COUNCIL ASSESSMENT REPORT

SYDNEY WESTERN CITY PLANNING PANEL

| PANEL REFERENCE & DA NUMBER | PPSSWC-251 – DA-267/2022 |
| PROPOSAL | Construction of six (6) residential flat buildings and two (2) shop top housing developments containing a total of 219 residential apartments, and a 93 place centre-based child care centre above two basement levels including landscaping and site works. |

Figure 14: Height breach to Site A (Source: Rothe Lowman plans)

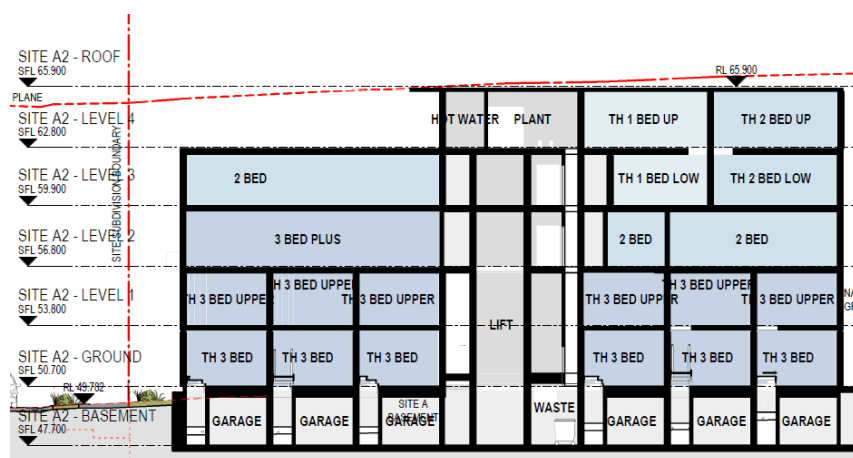
- In 15m portion: 15.35m (0.35m / 2.33% variation)
- In 12m portion: 14m (2m / 16.7% variation)

The architectural plan sections have identified where elements of the height are breached. Refer to the images below.

The applicant did not submit a height blanket to articulate the proportion of the development that protrudes into the maximum height plane. Accordingly, it is unclear if all plant areas on the roof have been identified as above or below the height in the applicant's submission.
